City of Portland, Maine – Building or Use Permit Application 389 Congress Street, 04101, Tel: (207) 874-8703, FAX: 874-8716

Location of Construction: 28 Morse St		Owner: Barry, Kathleen		Phone: 773-5429		Permit No: 980942	
Owner Address:		Lessee/Buyer's Name:		Phone:		BusinessName:	
Contractor Name: James Merry		Address: 453 Gorham, Rd Scarborough, ME		Phone: 04074 839-5429		<div style="border: 2px solid black; padding: 5px; text-align: center;"> PERMIT ISSUED Aug 24 1998 CITY OF PORTLAND </div>	
Past Use: 1-fam		Proposed Use: Same		COST OF WORK: \$ 11,308.00 PERMIT FEE: \$ 75.00			
Proposed Project Description: A. Lift & Level House B. Put several new footing under existing footings C. Install new concrete floor over old floor D. Install new bulkhead		FIRE DEPT. <input type="checkbox"/> Approved <input type="checkbox"/> Denied Signature: _____		INSPECTION: Use Group: _____ Type: _____ Signature: _____		Zone: _____ CBL: 163A-A-013	
						PEDESTRIAN ACTIVITIES DISTRICT (P.A.D.) Action: <input type="checkbox"/> Approved <input type="checkbox"/> Approved with Conditions <input type="checkbox"/> Denied Signature: _____ Date: _____

DATE: 8/21/98 ADDRESS: 28 Morse St
 REASON FOR PERMIT

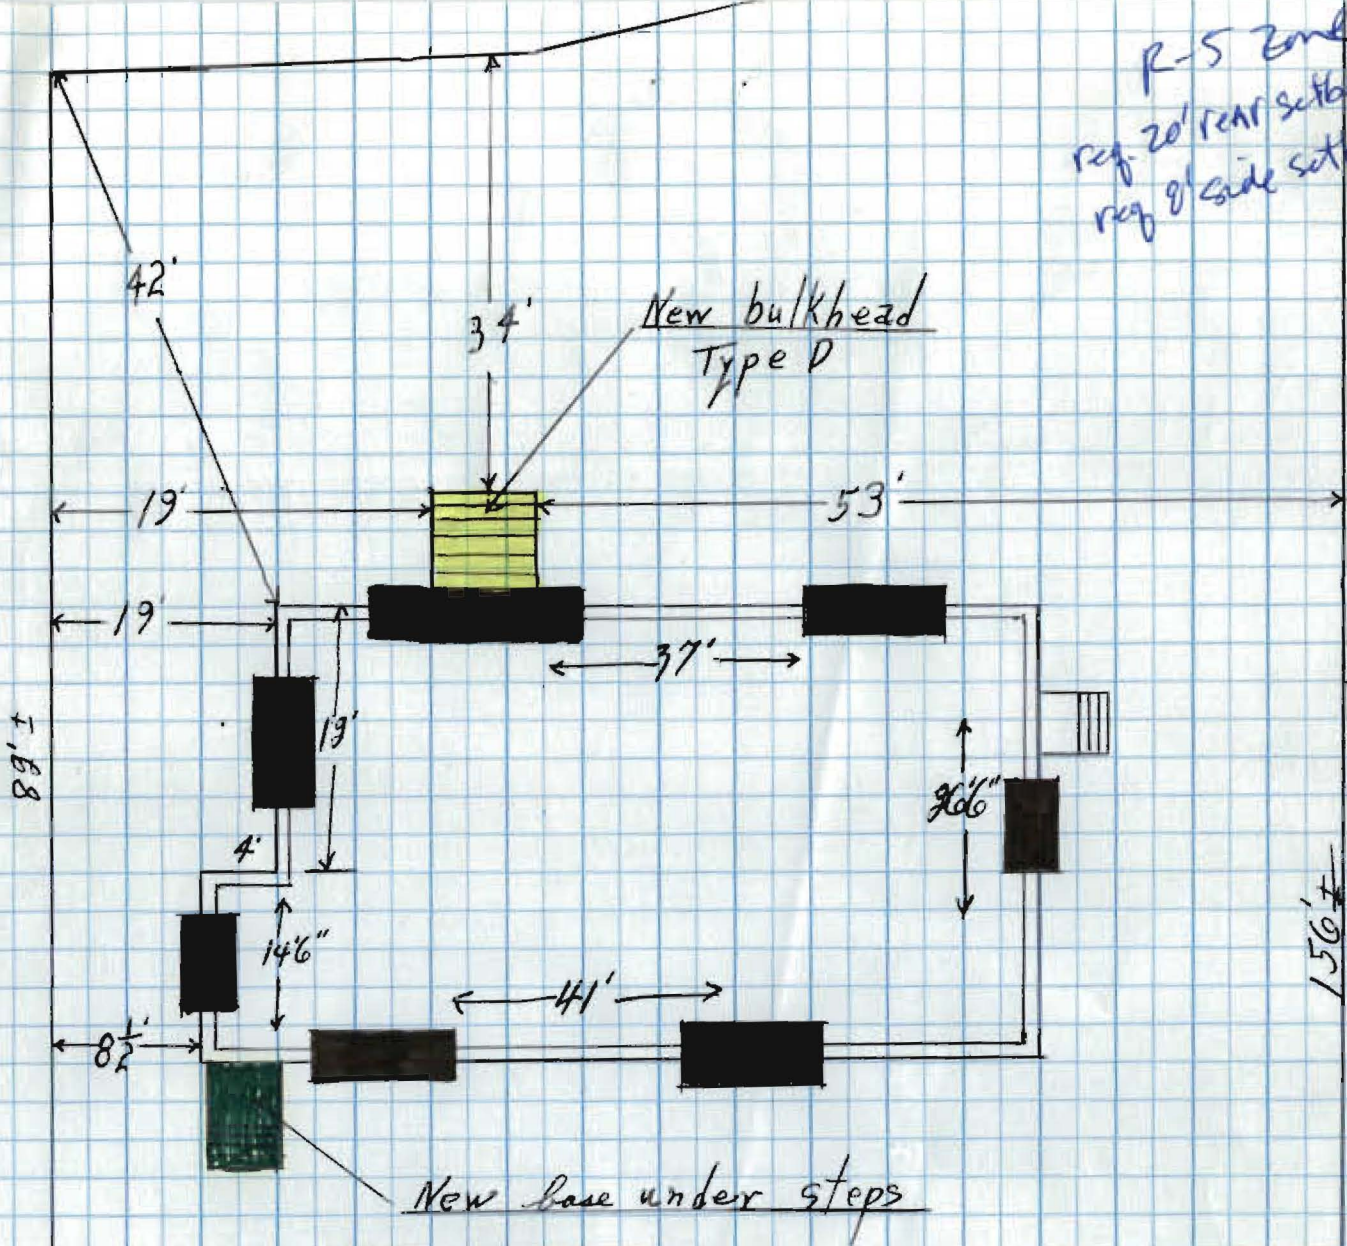
R-5 Zone
 req. 20' rear setback - 34' shown
 req. 9' side setback - 19' & 53' shown

New perimeter Bulkhead
 New concrete bases under footings
 New concrete base for front steps

Figure 2*

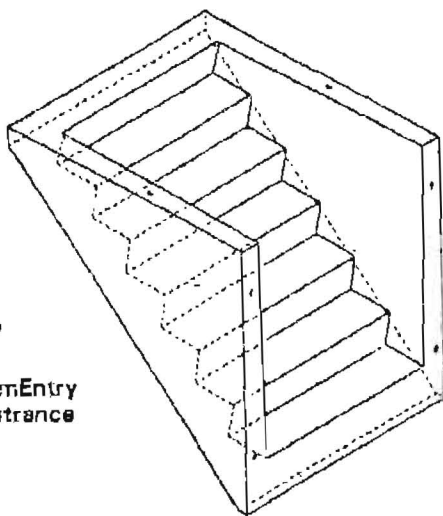
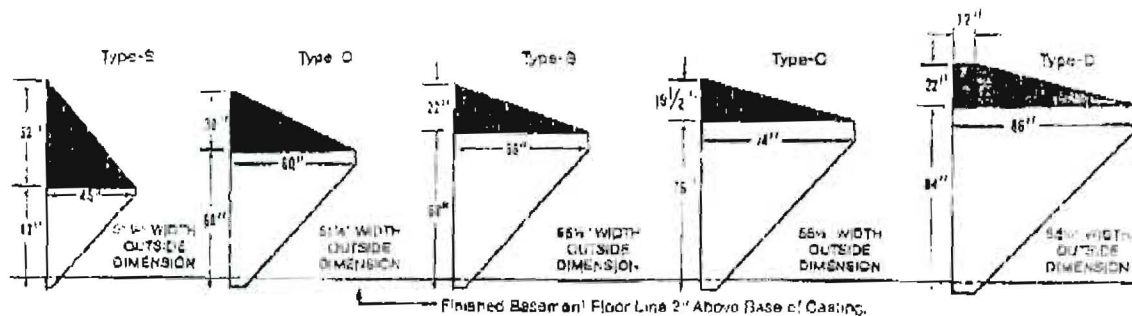
met w/ Jim Merry - New Bulkhead Stairs do not conform to Tread/Riser & Wood Clearance specs - Jim will try to re configure and call back @ nwa is probably a doghouse IPO bulkhead

4 1/4-inch thickness at the top and front to 5 1/4-inch thickness at the bottom and back of the castings. The treads of all PermEntry units are 8 5/8-inches and the risers are 8 1/4-inches. Figure 2 shows the available types and their dimensions.

Because the PermEntry basement entry does not conform to the requirements for minimum tread and maximum riser dimensions, the unit does not meet the requirements in the building code for stairways. Therefore, the PermEntry unit is being evaluated as an alternative to a ladder and for access to mechanical equipment and for emergency escape and shall not be considered to be an element of a means of egress.

9/17/98 BOCA RESEARCH REPORT ALLOWS CONFIGURATION AS AN EMERGENCY EGRESS. (VERIFIED 9/16/98)

MR. MERRY WAS ALLOWED TO INSTALL BUT MUST MAKE EVERY ATTEMPT TO MEET HEADROOM REQ. (80")
Ollie Cluff

- 4.2 The Bilco Company PermEntry basement entrance is an alternative to a ladder for access to mechanical equipment and for emergency escape and shall not be considered to be an element of a means of egress.
